Subject: **FIRMWARE UPGRADE—VERSION 5.0**

Model: **BKM-1450/2056**

Serial No: **2,002,191 AND HIGHER (BKM-1450)**
2,003,439 AND HIGHER (BKM-2056)

Figure 1

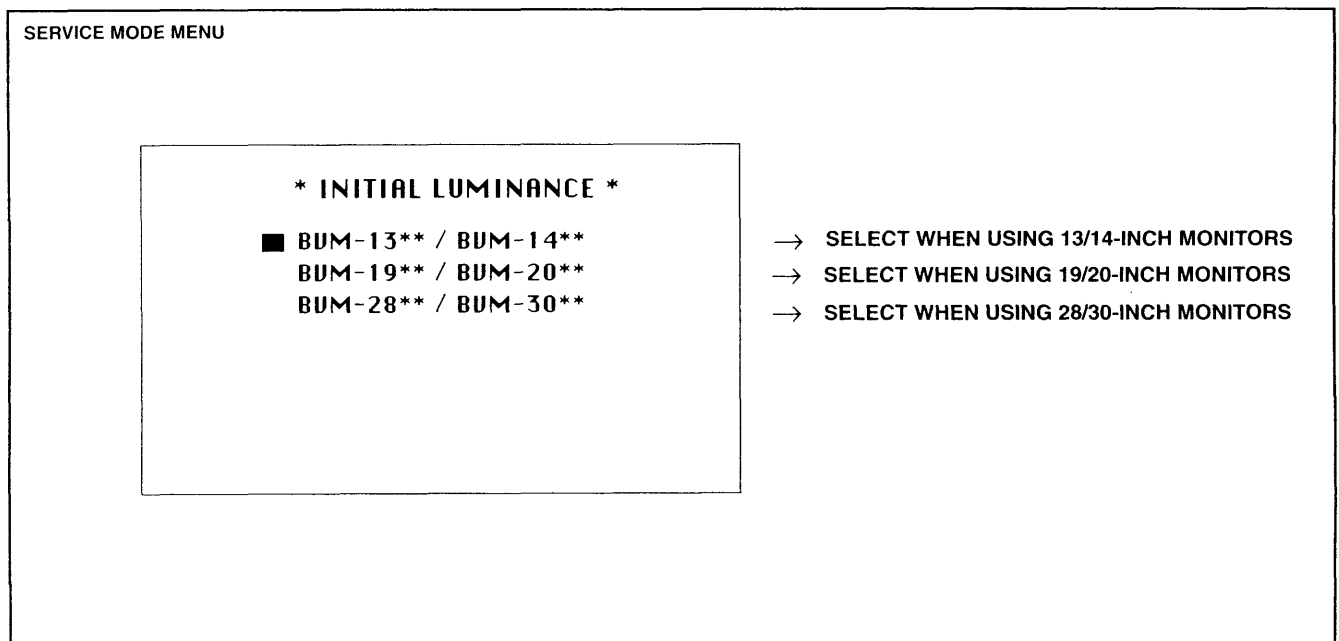
Firmware version 5.0 is now available. The new firmware implements the auto setup function for 30-inch BVM monitors. Figure 1 shows the luminance setup in the service mode menu. To install the new firmware, replace IC3 on the BN board with the new EPROM.
